June 27, 2011

RE: ASHTABULA COUNTY
HARPERSFIELD TOWNSHIP
CORK ELEMENTARY
NPDES PERMIT NO. OHC000003
OHIO EPA PERMIT NO. 3GC04767*AG
CONSTRUCTION STORM WATER

Figure 4. Disturbed soil that will remain idle for 21 (+) days needs to be stabilized.

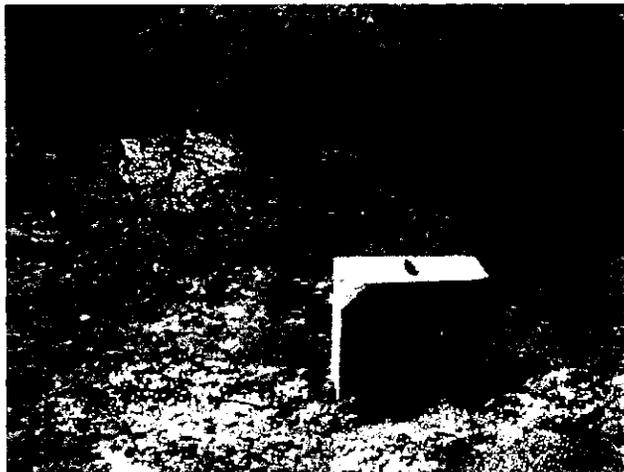
- There are areas throughout the site that need to be stabilized with seeding and straw mulch, specifically by the pond. Any disturbed earth throughout the site that will remain idle for twenty one (21) days or greater needs to be stabilized (See Figure 4).
